**Re: Petition No. 1534 Groton Utilities petition for a declaratory ruling, pursuant to Connecticut General Statutes §4-176 and §16-50k, for the proposed modifications to its existing Buddington Substation located at the intersection of Buddington Road and Gold Star Highway in Groton, Connecticut, and related electric transmission line structure improvements**

Petition No. 1534

**Groton Utilities Responses to the September 13, 2022  
First Set of Interrogatories Directed to Groton Utilities**

DATE	BY	REVISION
<div> <b>GROTON UTILITIES</b></div>		
SEDIMENTATION & EROSION CONTROL PLAN		
BUDDINGTON SUBSTATION BUDDINGTON ROAD GROTON, CONNECTICUT		
SURVEY BY: G.U.	DATE: 06/01/2022	SCALE: 1"= 30'
BASE PLAN BY: G.U.	DATE: 06/08/2022	DWG. NO.
DESIGN BY: G.U.	DATE: 09/23/2022	SHEET 1 OF 1

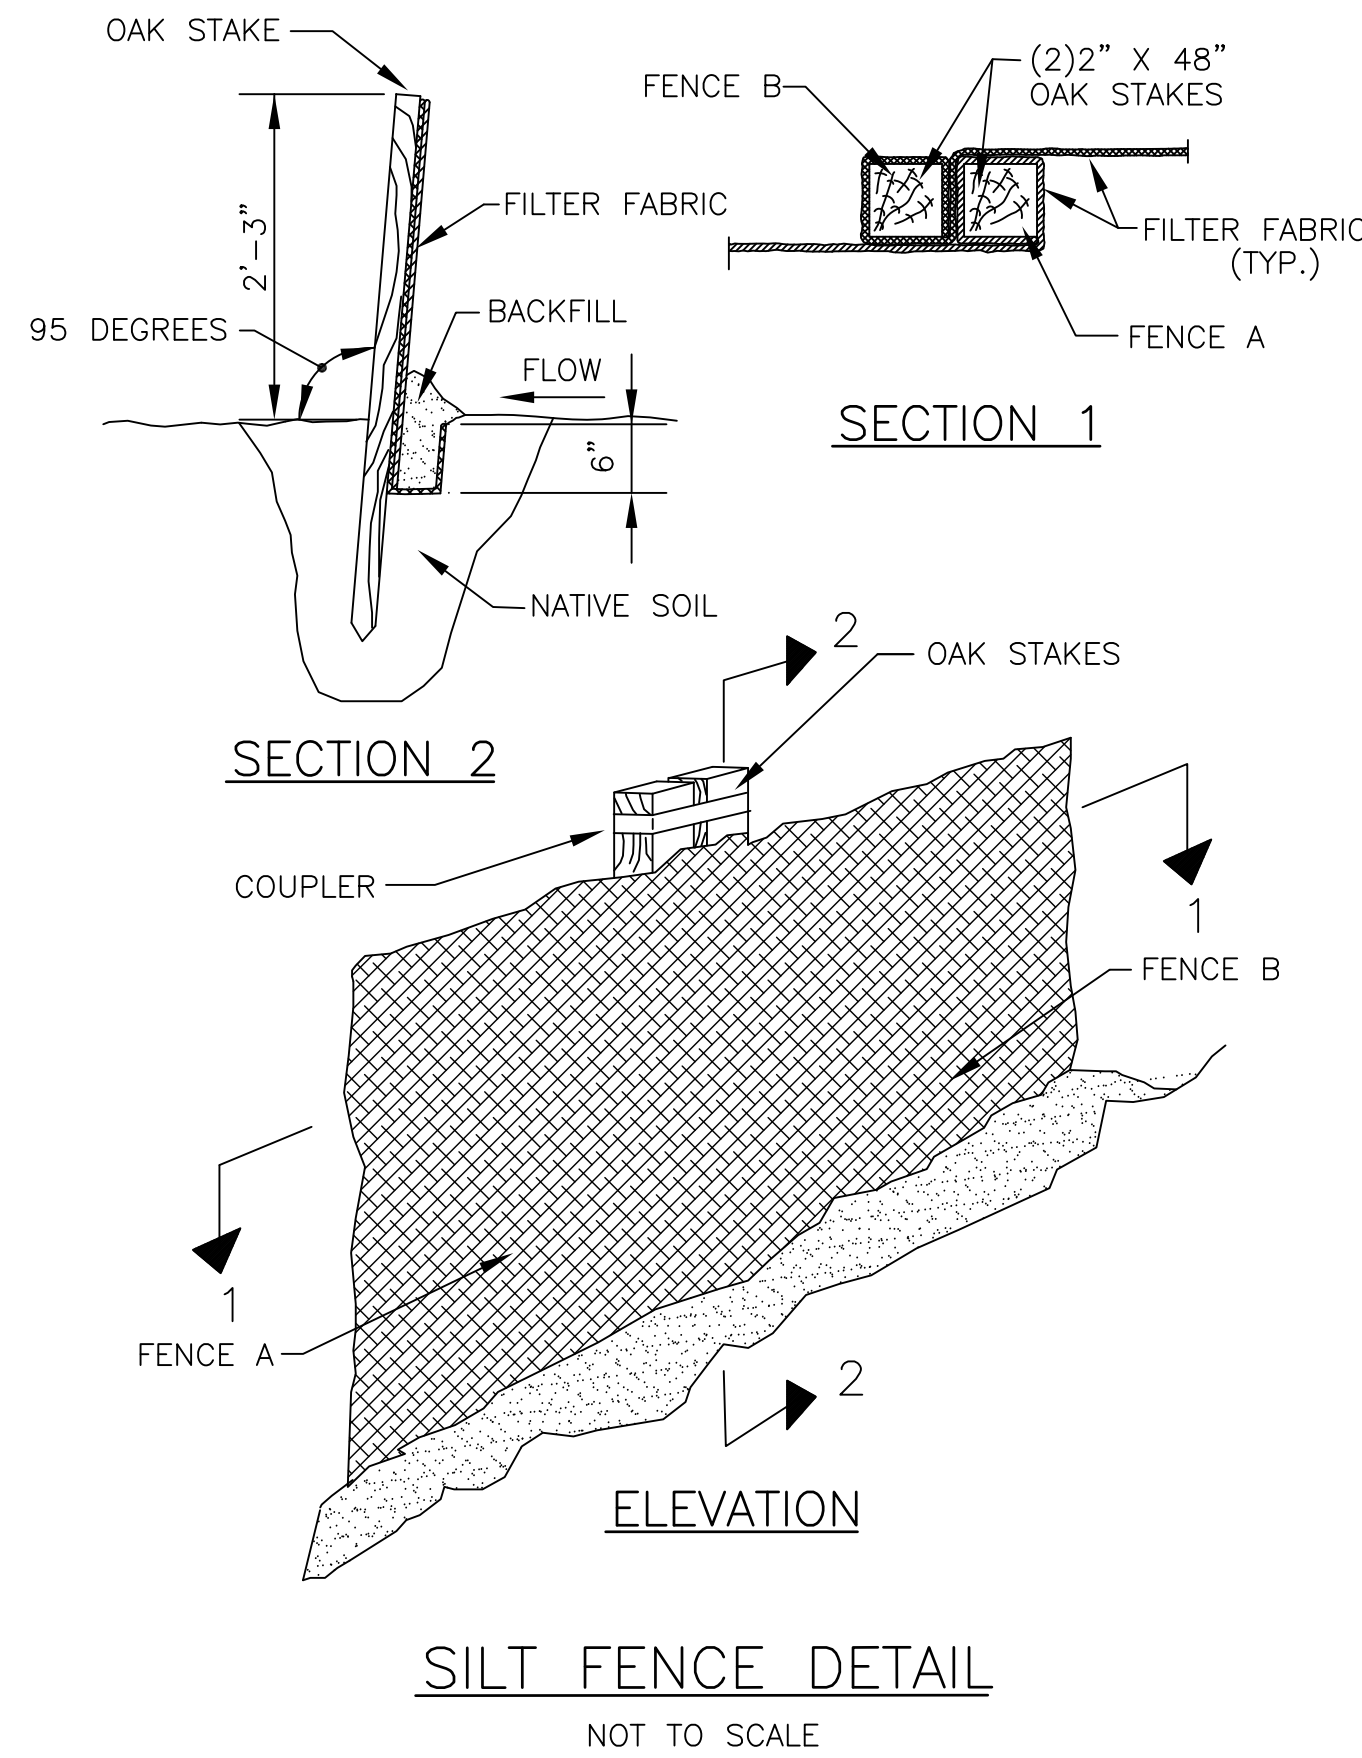
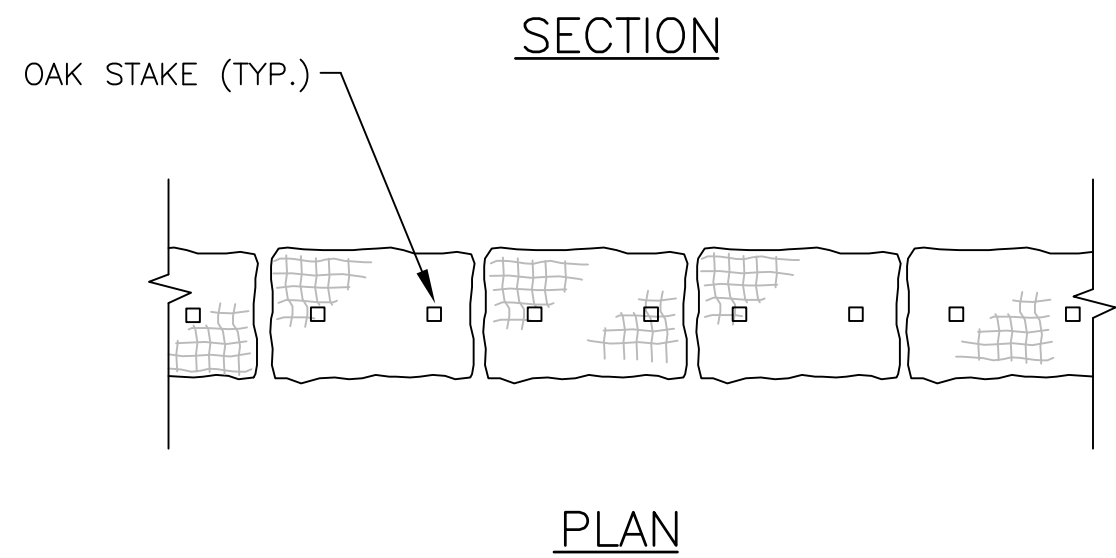
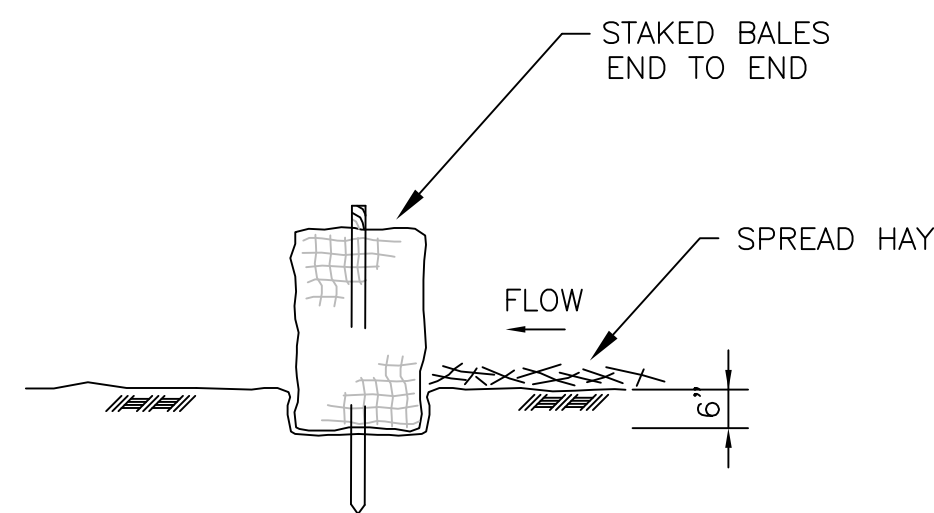
10. What erosion and sedimentation control measures would be utilized at the substation site during construction?

See response to question 9. above. In addition, GU is providing a copy of its Soil and Erosion Plan as Addendum B.
